To:	Sean Kearney	At:	Doma Group
From:	Benjamin Park	At:	SLR Consulting Australia Pty Ltd
Date:	22 October 2020	Ref:	620.30106-M01-v2.0 42HSD Traffic Engineering Response 2020 10 22.docx
Subject:	42 Honeysuckle Drive Hotel Development Response to Submissions Traffic Engineering Matters

SLR Consulting Pty Ltd (SLR) has been engaged by Doma Holdings (Honeysuckle) Pty Limited (DOMA) to provide traffic and transport advice with respect to 42 Honeysuckle Drive Newcastle and the application to modify the existing development approval.

This letter has been updated as version 2 (v2.0) and incorporates additional responses to comments made by TfNSW which were not included in the previous version submitted to the State (v1.0 dated 17 September 2020). Table 1 summarises the location within this memorandum where responses have been prepared to the items addressed above.

Figure 2 Bykko Stations – Honeysuckle, Newcastle CBD and Surrounds

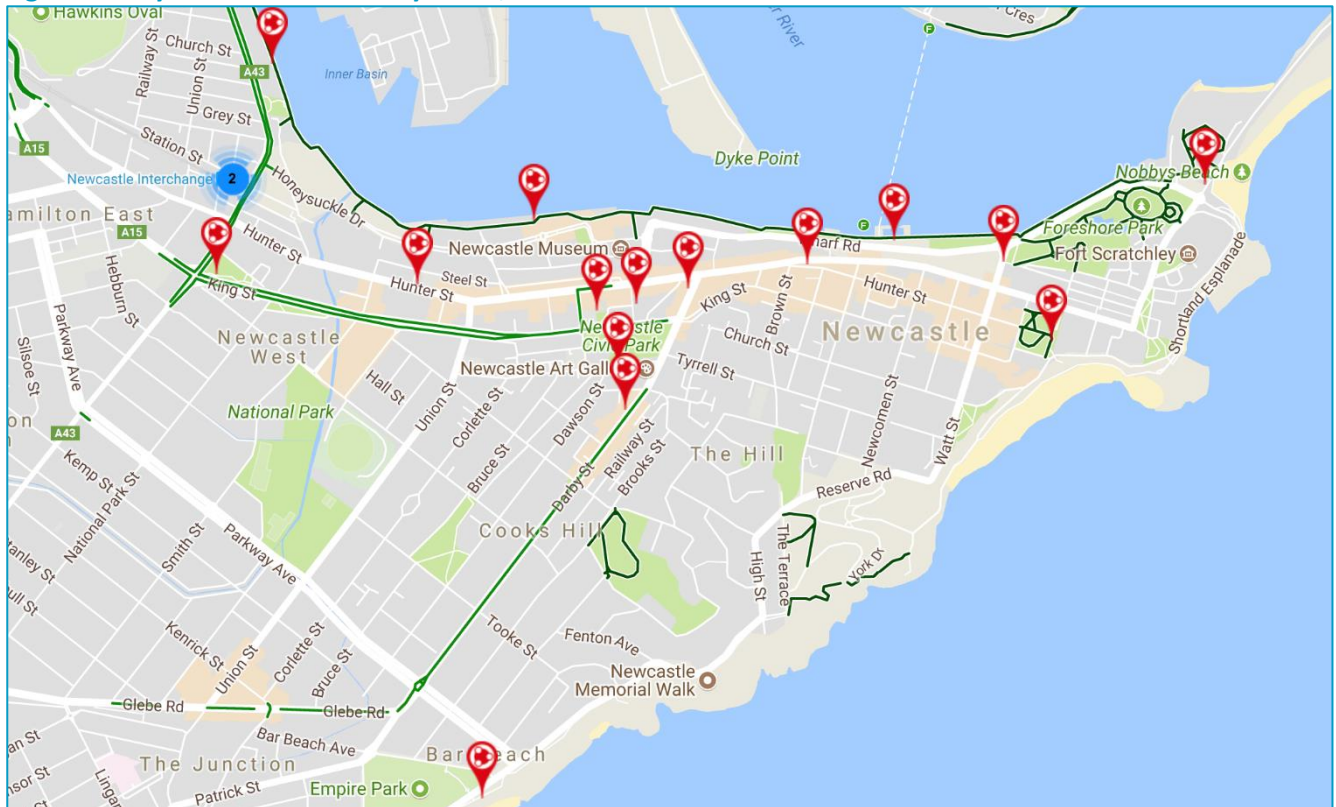
<p><u>Bicycle Storage</u></p> <p>The development includes a bicycle storage area for up to 48 bicycle spaces on the ground floor. According to the Traffic Impact Assessment (TIA), the NDCP requires 63 spaces and therefore the development has a deficiency of 15 bicycle spaces. It is argued that the NDCP parking rate 'is not appropriate for the size of the development proposed and that the generation rate for such a large development should be less than the DCP requirement.' No supporting evidence is provided to validate this statement.</p> <p>It is also argued that the hotel is unlikely to generate much demand for bicycle parking. The TIA does not indicate how many of the proposed spaces are allocated to the non-residential uses and the hotel. Based on the NDCP rate of 1 space per 20 units the hotel requires 9 spaces. According to the EIS (Pg14), the number of hotel rooms has increased from the previously approved development as a direct growth in the tourist sector. Given the city centre location of the development and proximity to the harbour foreshore cycleway it is considered desirable that hotel guests have access to non-car modes of transport to explore the city.</p> <p>Given the above circumstances, it is recommended more bicycle storage is provided in the development.</p>	Section 2.2

Item 10	<p><u>Bicycle Parking</u></p> <p>Please provide an assessment of the proposed bicycle parking provision in reference with the NDCP2012.</p> <p>Please also allocate the bicycle parking spaces according to their intended use.</p>	Section 2.2
Transport for New South Wales		
N/A	<p>The intersection of Hannell Street and Honeysuckle Drive has been observed to operate poorly particularly in the PM peak. TfNSW does not consider that the modelling provided within the TIA has been adequately calibrated as the queuing regularly extends several hundred metres.</p> <p>TfNSW have previously recommended to both the City of Newcastle (Council) and HCCDC that a study be undertaken to determine the impact of continuing intensification of the Honeysuckle catchment on the Hannell Street and Honeysuckle Drive intersection, and Hannell Street.</p> <p>It is noted that the upgrade of Honeysuckle Drive is underway which will increase vehicle storage on approach to the Hannell Street Traffic Control Signals (TCS), likely improving the operation of the TCS.</p> <p>TfNSW consider that the subject development will be a smaller contributor to the overall congestion than the remaining development sites along Honeysuckle Drive, and raise no objection to the proposal.</p>	Section 6

Furthermore, surrounding the subject site are a number of shared electric bike stations operated by Bykko which, combined with the nearby light rail, provide employees and guests of the proposed development with a number of high-quality non-vehicle travel modes. Figure 2 illustrates the location of the surrounding stations within roughly 4kms of the subject site.

The nearest Bykko shared bike station is located on Hunter Street approximately 350m walk from the subject site, which facilitates travel to the surrounding 15+ stations throughout Newcastle and surrounding suburbs.

Figure 5 Dynamic Parking Demand based on First Principles (Typical Weekday)

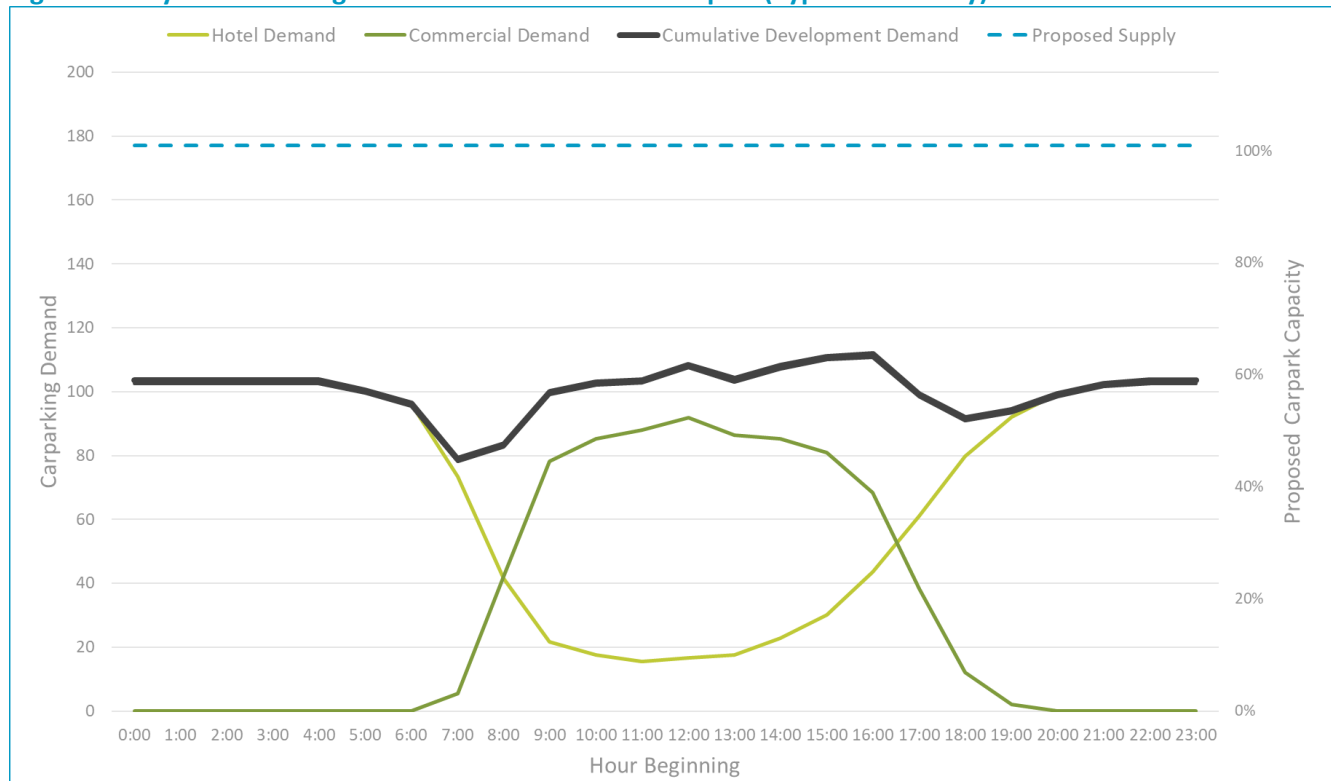
Item 3	<p><u>Car Parking</u></p> <p>The Newcastle Development Control Plan (NDCP) 2012 provides that parking for developments, other than residential in the City Centre, are calculated based on a 'flat' parking rate of 1 space per 60m² of Gross Floor (GFA) area. Based on a GFA of 12,510m² and the above parking rate the development requires 209 spaces. The submitted plans provide a total of 173 spaces, and therefore equates to a deficiency of 36 spaces.</p> <p>The Traffic Impact Assessment (Amended Feb 2020), prepared by Intersect Traffic Pty Ltd has calculated the required parking for the hotel based on a parking rate for outside the City Centre, that is, 1 space per 2 staff plus a minimum 0.5 spaces per room and a maximum 1 space per room. Based on this ratio, the hotel component requires 100 parking spaces compared with 119 spaces based on the City Centre rate.</p> <p>For the commercial component, it is argued that a rate of 1 space per 75m² GFA is appropriate given the same rate was accepted by CN for a development (DA2018/01107) comprising a 12 storey commercial development with ground floor retail and basement car park at 6 Stewart Avenue Newcastle. It is also stated that the basis for the proposed concession, as detailed in the supporting traffic report, was also accepted by the Hunter and Central Coast Joint Regional Planning Panel (HCCJRPP).</p> <p>An examination of the above development application documentation does not support such claims. The CN's Assessment Report dated 28 February 2018 to the HCCJRPP identifies the parking deficiency of the development as one of the primary concerns of CN staff in respect of traffic and parking. It was recommended that this concern be addressed by the imposition of an appropriate condition on the consent. Accordingly, condition C21 of the development consent granted by the HCCJRPP required the provision of 278 onsite parking spaces as required by the NDCP. Given the above circumstances, it is considered that the EIS has not satisfactorily justified the variation from the above City Centre parking rate and it is recommended the applicant amend the design to ensure satisfactory compliance with the requirements of the NDCP.</p>	Section 3

Item 8	<p><u>Car parking assessment</u></p> <p>The Department notes that the traffic study attached to the application has relied on the car parking rate permitted at 6 Stewart Avenue, Newcastle.</p> <p>The EIS states that the arguments raised are valid for this proposal as well. Please outline the nature of this argument in reference to 42 Honeysuckle Drive.</p> <p>Please provide detailed car parking calculations to refer to the rates identified in the NDCP 2012.</p>	Section 3

Using the first principles parking demand rates as a baseline parking demand for each land use as summarised in Section 3.2 were applied to the demand profile illustrated in Figure 4 to ascertain what the cumulative parking demand of the site would likely be. The results of this dynamic parking assessment are illustrated in Figure 5.

This assessment suggests that if the proposed development were to provide parking in-line with the minimum rates suggested in the Newcastle DCP, the demand would not exceed 112 spaces which equates to approximately 63% of the proposed carpark capacity during weekdays.

Figure 7 Existing Condition Assessment Results

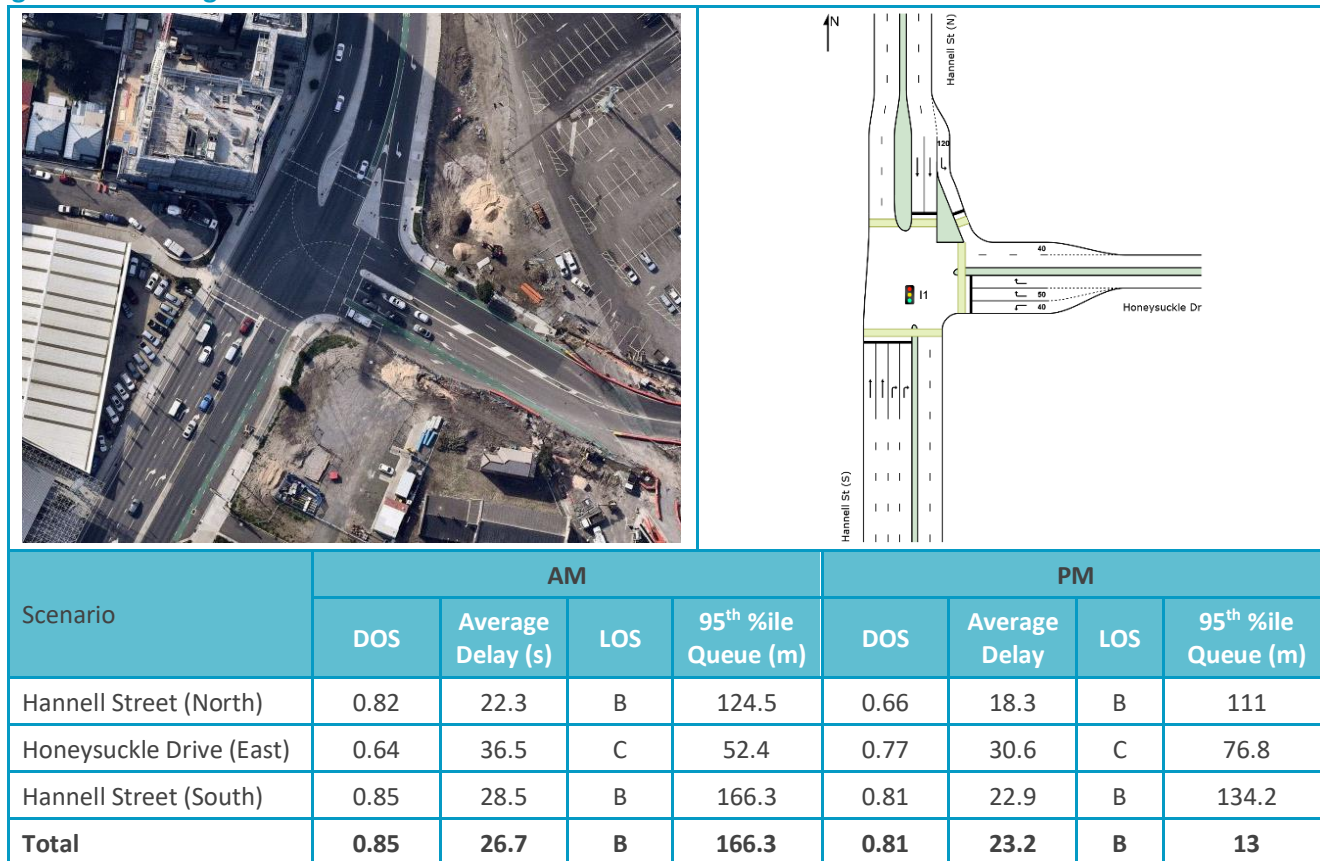
TfNSW has identified that Hannell Street / Honeysuckle Drive intersection assessment presented in the original TIA (prepared by Intersect Traffic, February 2020) was not accurately representing the queue lengths during PM peak periods. SLR has revised this traffic analysis on the subject intersection to better replicate existing conditions as reported by TfNSW, and also accounting for the updated development traffic generation highlighted in Section 5

The updated intersection assessment has been completed in SIDRA Intersection 9.0. Figure 7 illustrates the adopted existing intersection configuration and summarises the results of the existing conditions assessment which reflects the longer queue lengths reported by TfNSW.

The results summarised above demonstrates that the intersection is operating near capacity (typical DOS of 0.9) with reported 95th percentile queues on the northern and southern approaches of Hannell Street extending between 100m and 200m in peak periods.

It should be noted that these queues may extend further than what is being reported by SIDRA due to downstream effects caused by the light-rail crossing and nearby signalised intersections. Irrespective of these additional factors, the assessment herein only considers incremental development traffic impacts, which are anticipated to be the same with or without consideration of these surrounding network elements.

Figure 9 Sight Distance to Pedestrians

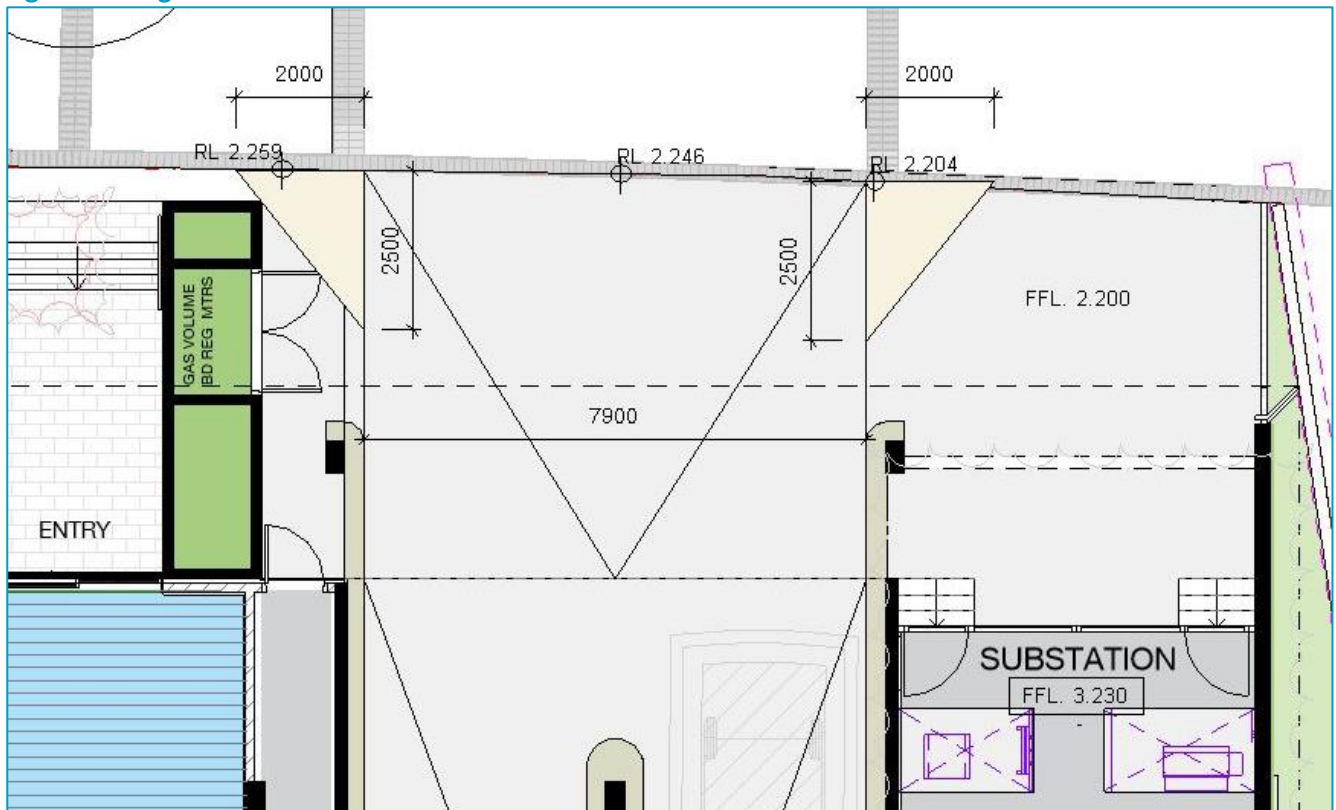
N/A	<p>DPiE should have consideration for appropriate sight line distances in accordance with Section 3 of the Austroads Guide to Road Design Part 4A (Unsignalised and Signalised Intersections) and the relevant Australian Standards (i.e. AS2890:1:2004) and should be satisfied that the location of the proposed driveway promotes safe vehicle movements.</p>	Section 7

TfNSW has requested confirmation that the development meets the requirements of *AS2890.1 Off-Street Car Parking* with regard to vehicular sight lines for vehicles leaving the development. Specifically, clarifying the development complies with *Section 3.2.4 Sight Distance at Access Driveway Exits* for entering sight distance and sight distance to pedestrians.

Figure 9 shows that the development meets the AS2890.1 requirement for sight distance to pedestrians with two (2) 2m x 2.5m sight triangles on both sides of the access driveway.
